Office Action Summary	Application No. 10/575,526	Applicant(s) SPITZ ET AL.	
	Examiner Hsin-Yi (Steven) Hsieh	Art Unit 2811

DETAILED ACTION***Drawings***

6. **Claims 15, 16 and 26** are rejected under 35 U.S.C. 102(b) as being anticipated by Spitz et al. (US 6,060,776 A).

A portion of Fig. 1 of Spitz et al. showing the trench and the first bevel

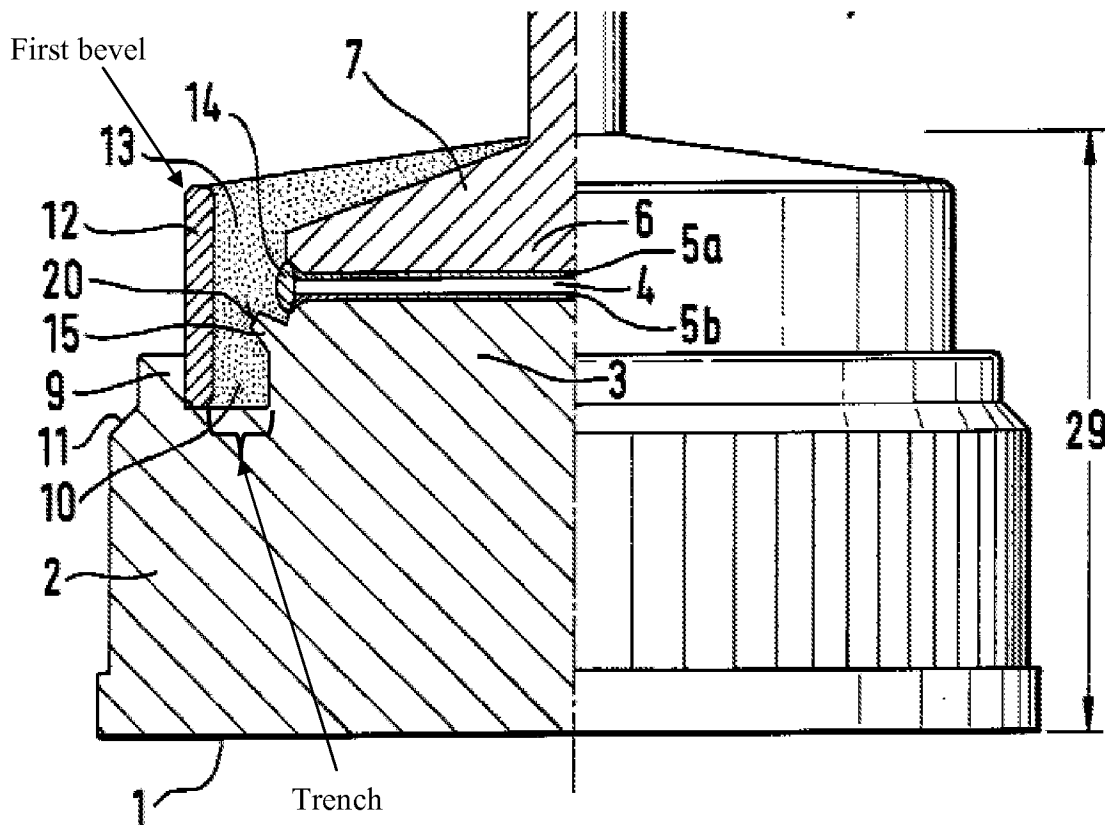
7. Regarding **claim 15**, Spitz et al. teach a press-fit diode (rectifier diode 100; Fig. 1, col. 3 lines 15-16), comprising: a head wire (8; Fig. 1, col. 3 lines 21-22); a base (2; Fig. 1, col. 3 line 17); a chip (semiconductor chip 4; Fig. 1, col. 3 lines 19-20) connected via solder layers (solder 5a and 5b; Fig. 1, col. 3 lines 19-21) to the head wire (8) and to the base (2; Fig. 1, col. 3 lines 18-21); at least a first bevel (the bevel at the top outer corner of 12; see Fig. 1 below) located at a top (12 is a top portion of 12, 13, and 2; see Fig. 1 below) of a housing (12, 13 and 2) and a second bevel (press-fit region 11; Fig. 1, col. 3 line 25) located at a bottom (2 is a bottom portion

of 12, 13, and 2) of the housing (12, 13 and 2), wherein the first and second bevels (the bevel at the top outer corner of 12 and 11) enable press-fitting of the diode (100; the bevel at the top outer corner of 12 eases the insertion of the diode and 11 is pressed fitted to the rectifier arrangement 36; see Figs. 2 and 3, col. 4 lines 32-54); and a plastic sheathing (protective sheath 12 and a package 13 of casting resin composition; Fig. 1, col. 3 lines 30-32 and 66-67) which includes a sleeve (protective sheath 12; Fig. 1, col. 3 lines 30-32) and is situated at least in an area around the chip (4; the sleeve 12 surrounds the chip 4; see Fig. 1) and forms a mechanical connection between the base (2) and the head wire (8; see Fig. 1, the sleeve 12 is mechanically connected to 2 and 8), wherein the base (2) at least partially encloses the plastic sheathing (12 and 13) and forms the housing (12, 13 and 2) with the plastic sheathing (12 and 13), and wherein the base (2) includes at least one undercut (shoulder 15; Fig. 1, col. 3 lines 36-37) which extends into the plastic sheathing (12 and 13; see Fig. 1), and wherein a trench (the trench between 12 and 2 filled with 13; see Fig. 1 below) is provided between the sleeve (12) of the plastic sheathing (12 and 13) and the base (2; see Fig. 1 below).

A portion of Fig. 1 of Spitz et al. showing the trench and the outer area of base

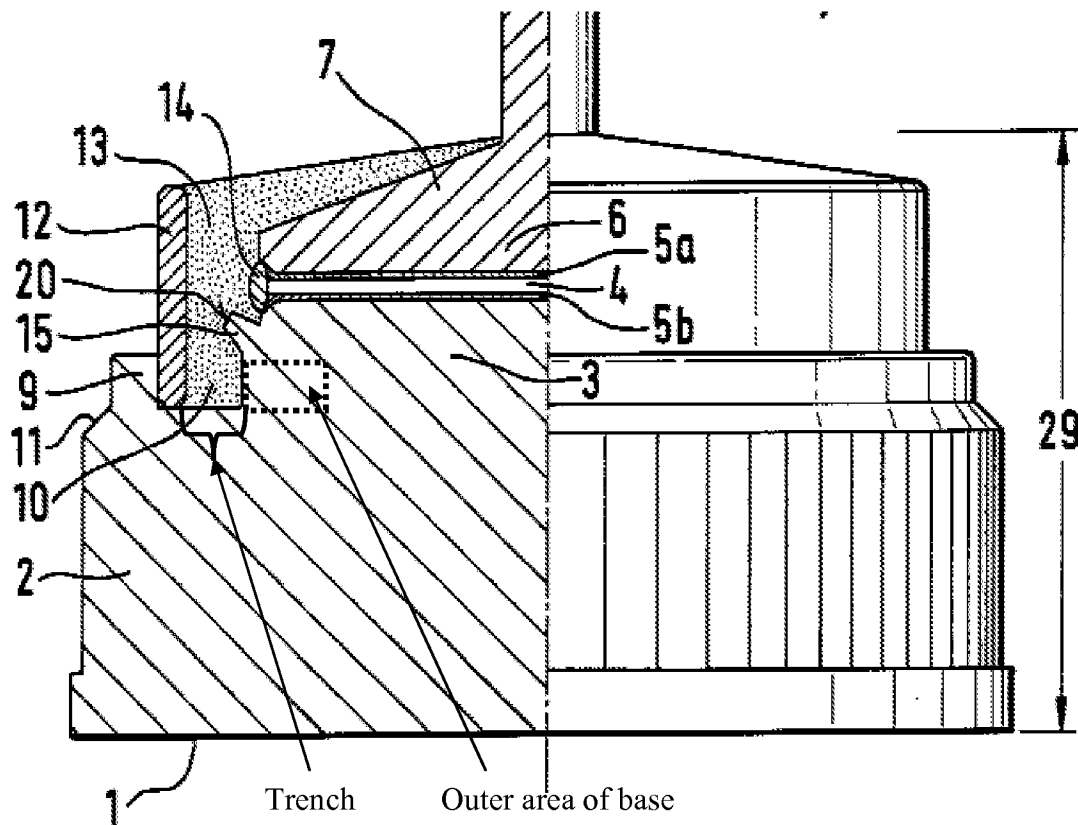
16. Regarding **claim 20**, Spitz et al. also teach the press-fit diode as recited in claim 17, wherein the trench (the trench between 12 and 2 filled with 13) has a predetermined depth (see Fig. 1 below) and is provided between the sleeve (12) and an outer area of the base (a portion of base 2 in contact with the right hand side of the trench 10; see the figure below).

A portion of Fig. 1 of Spitz et al. showing the first area and the second area

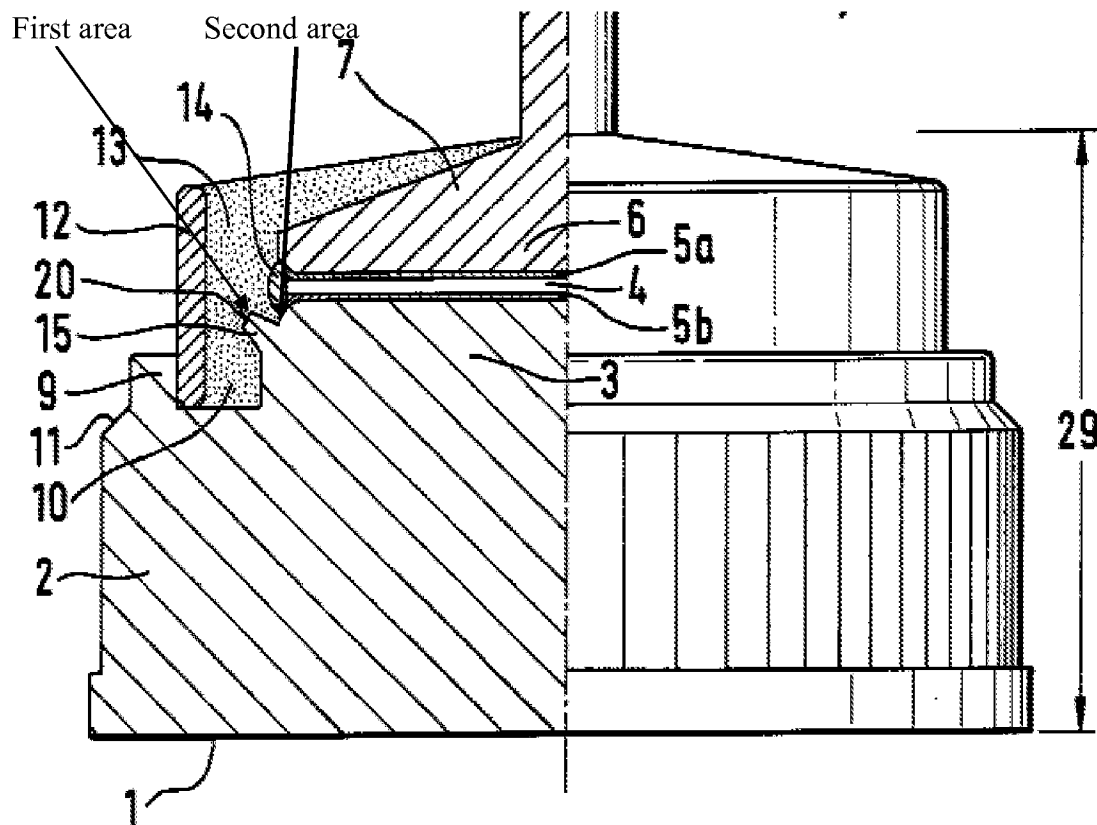
20. Regarding **claim 24**, Spitz et al. also teach the press-fit diode as recited in claim 17, wherein the base (2) includes an outer region (shoulder 15; Fig. 1, col. 3 line 37) having a first area (top area) with a first inner diameter (the diameter corresponds to the inner side of the shoulder 15 at the top) and a second area (lower area) with a second inner diameter (the diameter corresponds to the inner side of the shoulder 15 at a lower position) smaller than the first inner diameter (see the figure below).
